DEPARTMENT OF TRANSPORTATION**National Highway Traffic Safety Administration****49 CFR Part 572****[Docket No. NHTSA-02-12541]****RIN 2127-AI00****Anthropomorphic Test Devices; Six-Year-Old Crash Test Dummy****AGENCY:** National Highway Traffic Safety Administration (NHTSA), Department of Transportation.**ACTION:** Final rule; response to petitions for reconsideration.

SUMMARY: This document responds to petitions for reconsideration of the final rule that adopted a new, more advanced 6-year-old child dummy (HIII-6C). That final rule was published January 13, 2000 (65 FR 2059, Docket No. NHTSA-99-6714). Adopting the dummy was the first step toward using the dummy to evaluate the safety of air bags for children. The petitions are granted in part and denied in part.

Figure N 2
NECK FLEXION TEST SET-UP SPECIFICATIONS

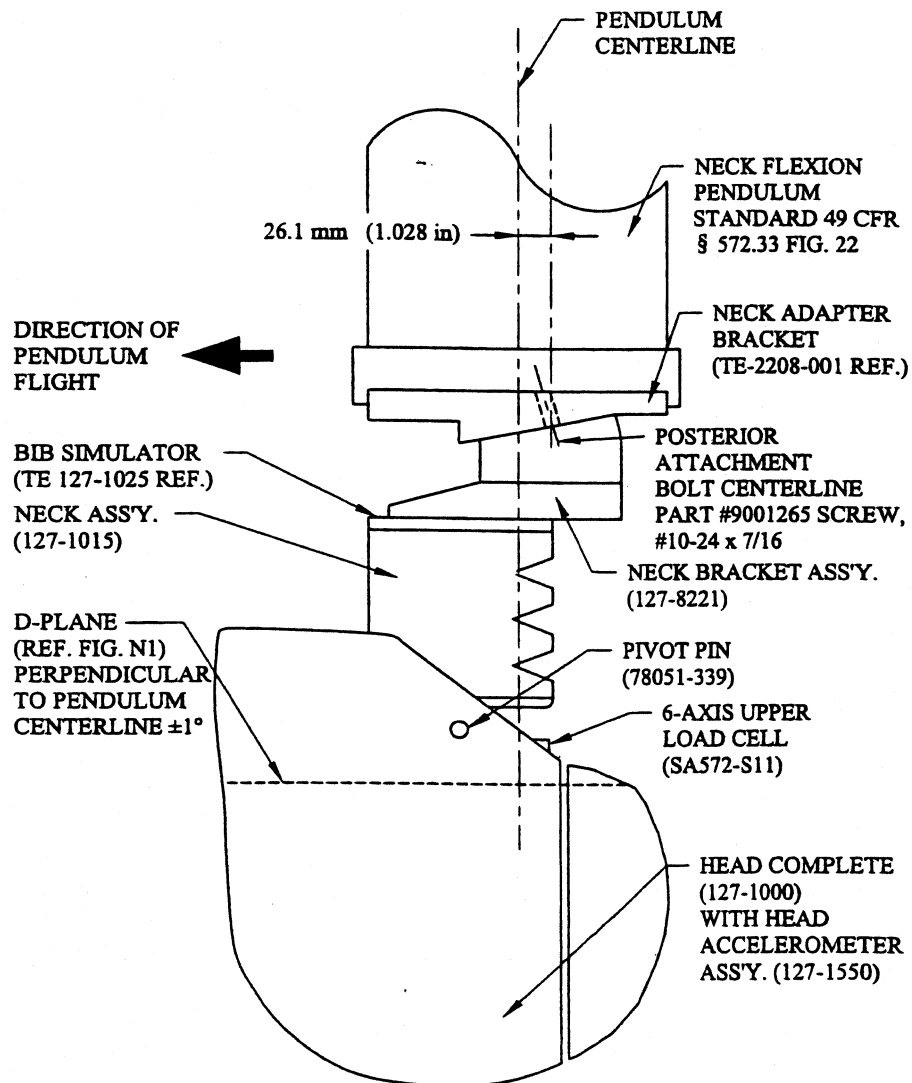
- Figure N2: (1) Relocate the 26.1 mm reference to the centerline of the posterior attachment bolt to reflect dimensional proportionality; (2) change reference from "Neck Flexion Pendulum 46 CFR 572.33 FIG 22" to "Neck Flexion Pendulum 49 CFR 572.33 FIG 22"; and (3) add part number for bolt "#9001265 Screw, SHCS #10-24 x 7/16".

Figure N 3

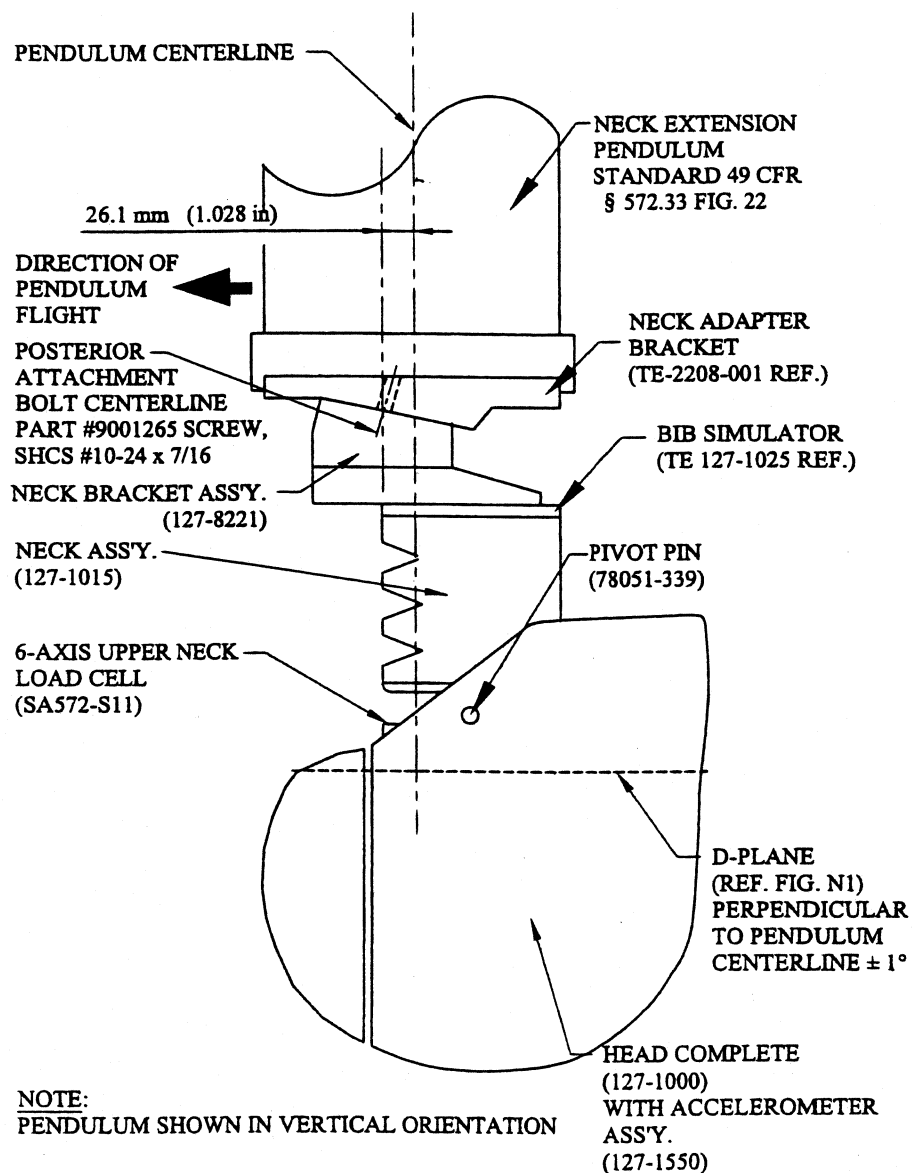
- Figure N3: (1) relocate the 26.1 mm reference to the centerline of the posterior attachment bolt to reflect dimensional proportionality; and (2) add part number for bolt "#9001265 Screw, SHCS #10-24 x 7/16".

FIGURE N 6
KNEE IMPACT TEST SET-UP SPECIFICATIONS

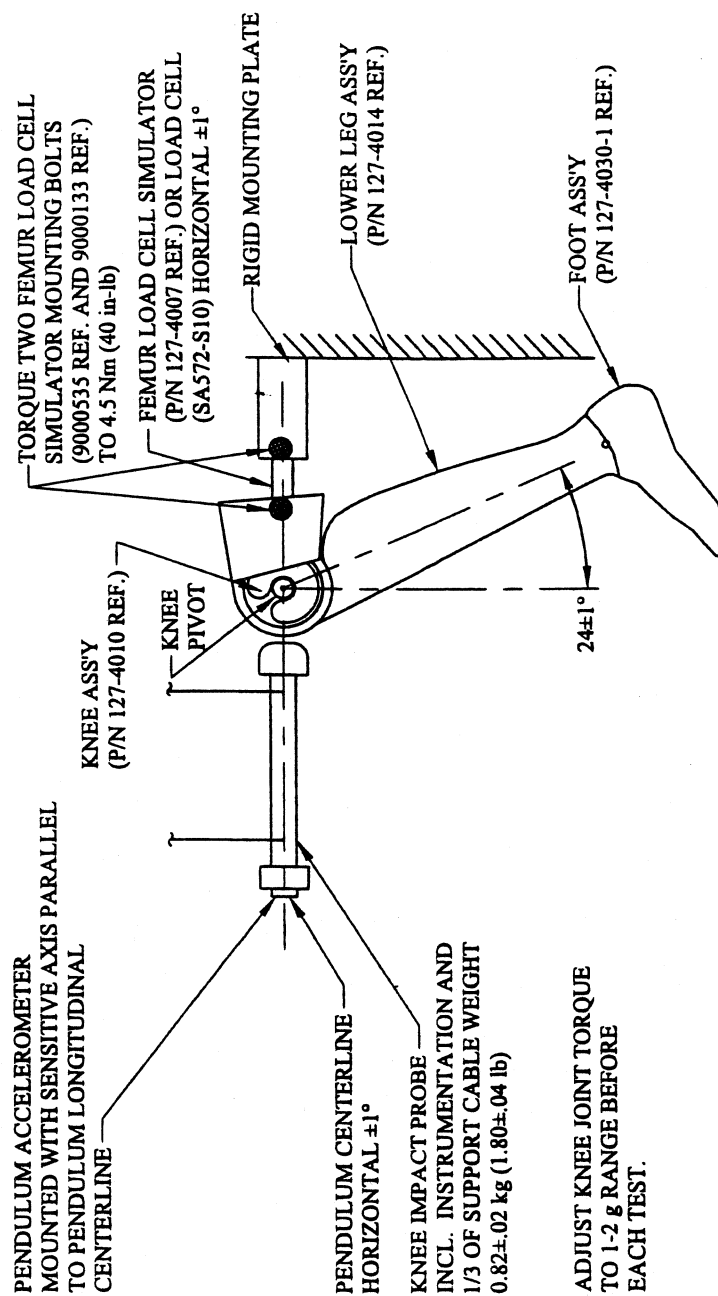
- Figure N6: (1) remove note SA572-S4; and (2) change the weight tolerance on the knee probe from " 0.82 ± 0.01 kg ($1.80 \pm .02$ lb)" to " 0.82 ± 0.02 kg ($1.80 \pm .05$ lb)".
